Lifschutz Davidson Sandilands

project	drawing title			
16-19 Gresse Street, London, W1	ground floor core plan			
client	scale at A1	scale at A3	drawn	date
Derwent Valley Holdings	1:33	1:66	SPC	01.06
	job no.	drawing	rev.	
	0382A	A2003	F

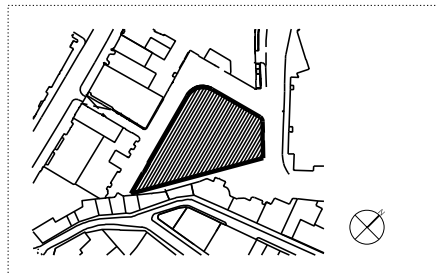
date	rev	revisions
05.02.09	E	Riser door DG 015 at grid ref 7-3 added and Riser door DG002 relocated. Small cross wall in riser at grid ref 7-3 omitted.Wall simplified at disabled call point. Access panel in stair 01 lobby revised to panels at high and low levels. At the 2no. full height extract grills, in the drylined wall behind is a fire damper and a lower level FR access panel. FR access panel set to RHS and set at 1350mm below FCL to centre of panel.Paint inside of cupboard white. All at Intech/Meica request.
13.02.09	F	Riser door DG 015 at grid ref 7-3 omitted at ground floor only.Access is required in this location on all upper floors.
